Sales & Service Bulletin | No. 2025/04 | November 01, 2025 | Page 1/1

New NO_x sensor generation and

parts number 56.03.005

MOTORTECH announces the latest NOx-sensor generation and design change.

56.03.003 (old design with metal bracket and design with plastic bracket).

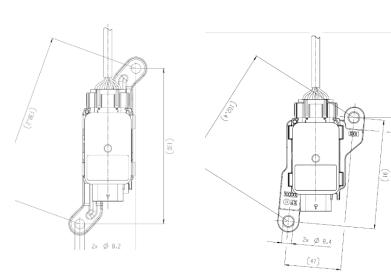
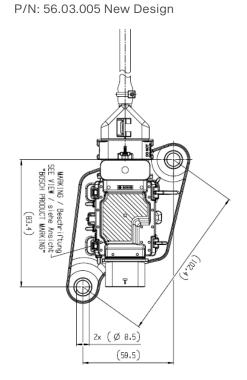
MOTORTECH will provide the NOx-sensor with the new parts number P/N: 56.03.005 and discontinue the predecessor P/N: 56.03.003.

In EasyNOx NOx-Monitoring applications the bracket design change is already considered at the mounting plate (P/N: 63.05.015) since 2022.

- 12/24V multi-volt level usage
- Three CAN IDs available to use up to 3 NOx-sensors in a fieldbus
- Improved accuracy
- Improved harness material and electronics housing

The new sensor has a different factory-set k_{NO2} factor than the predecessor model. In the EasyNOx settings, the k_{NO2} factor must be reset to 0.82 as a fixed manufacturer-specific value of the sensor (previously 0.85) as soon as sensor 56.03.005 is installed.
